SERVICE BULLETIN NO. OSB1078-174

ATA-Code: 11-30 Internal Placards and Markings
Marking of the canopy emergency release handle

Fig.

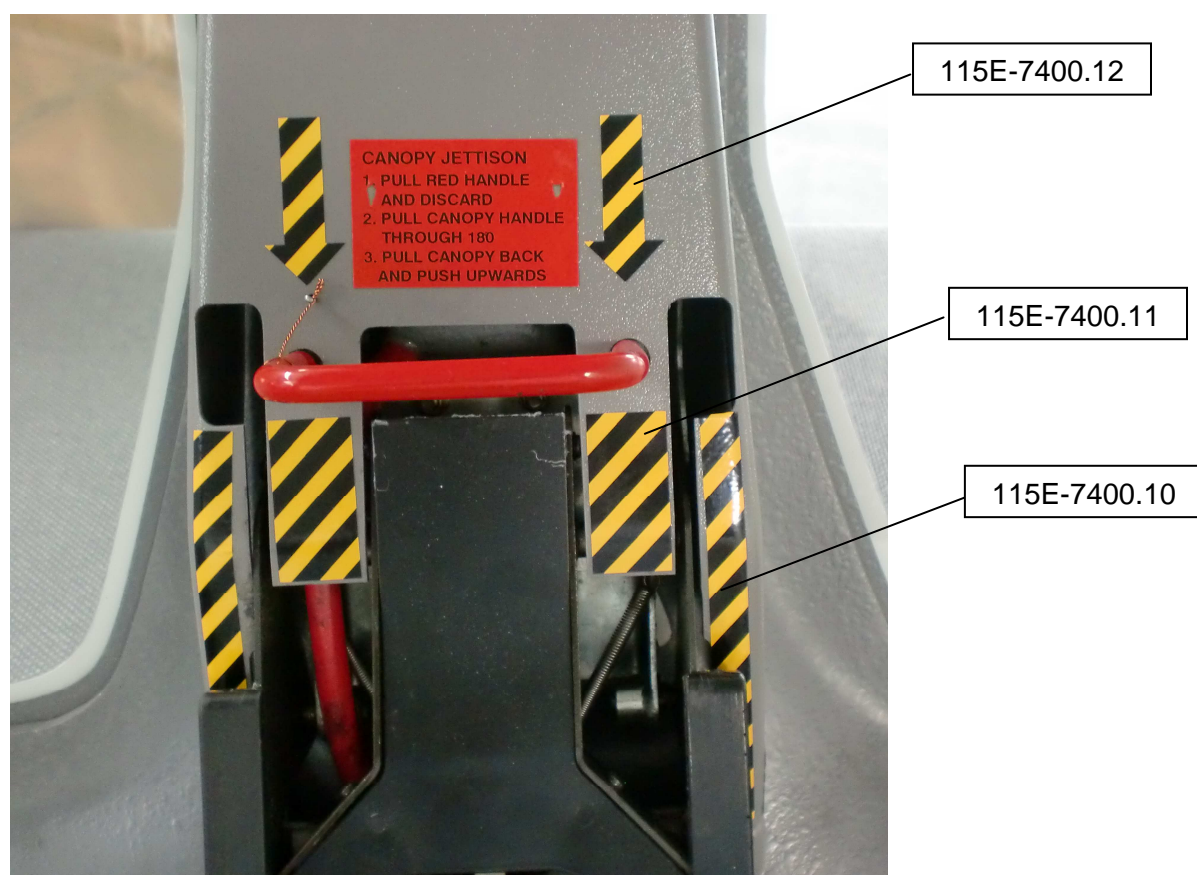
- 1.8.1 Ensure that the aircraft is safe for parking I.A.W. MM chapter 10-10.
- 1.8.2 Open canopy.
- 1.8.3 Apply yellow / black adhesive markings (qty. 2 P/N 115E-7400.10, qty. 2 P/N 115E-7400.11 and qty. 2 P/N 115E-7400.12) as shown in Fig. 1.
- 1.8.4 Release aircraft to service.
